**HUMAN FACTORS ENGINEERING
CONTROL-ROOM-DESIGN REVIEW/AUDIT REPORT;**

**PALO VERDE NUCLEAR GENERATING STATION,
ARIZONA PUBLIC SERVICE COMPANY**

Jack W. Savage
David A. Lappa
Lawrence Livermore National Laboratory

October 9, 1981

FIG. 1. Identification letters of the four control board surfaces.

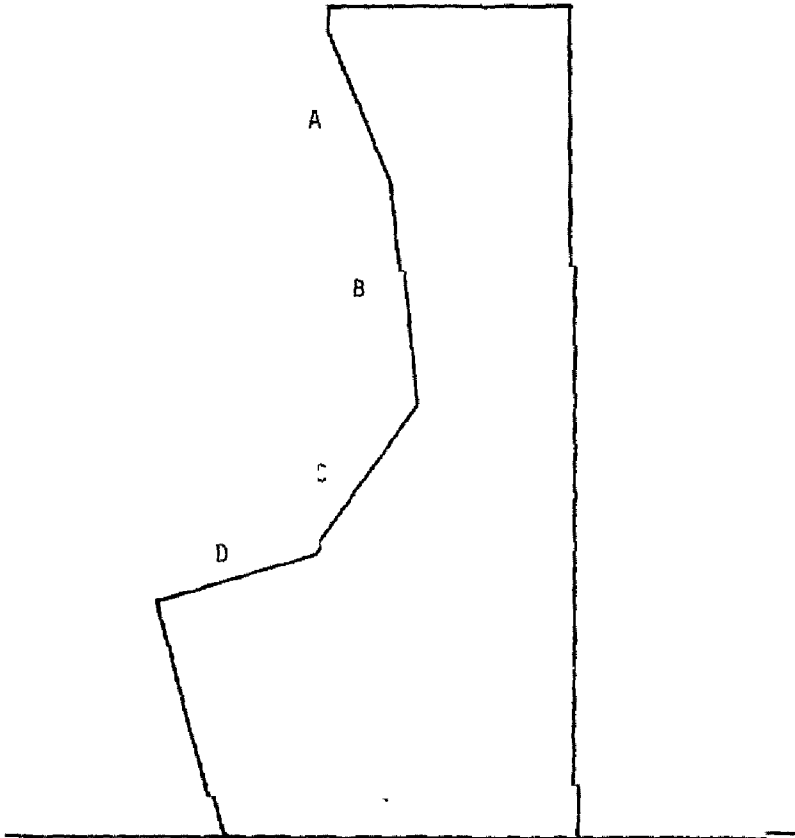
<u>PHOTO ID</u>	<u>REVIEWER</u>	<u>PRIORITY RATING</u>	<u>FINDING</u>
	JD,JS	3	1* The control room bookshelves are inadequate. (056C)
S1,H9	JD,JS	2	2* Glare is a problem for most displays on all of the panels. It is worst on the "C" surfaces, depending on viewing angle. (See Fig. 1 on page 3 for the meaning of "A", "B", "C, and "D" surfaces) (049C) (064C) (100B) (101B) (103C)
S2	JD,JS	1	3* Glare on CMC switch surfaces hinders "light-on" determination. This is more apparent on the "C" surfaces. A matte surface might not be as effective a solution as brighter lights. Example: (Panel B02) a) ESF SWGRA/EQPT Room switch (098C)
	JD,JS	3 ¹	4* The concrete control room floor is not carpeted, which will lead to earlier fatigue during long periods of standing by the operators. (068B)
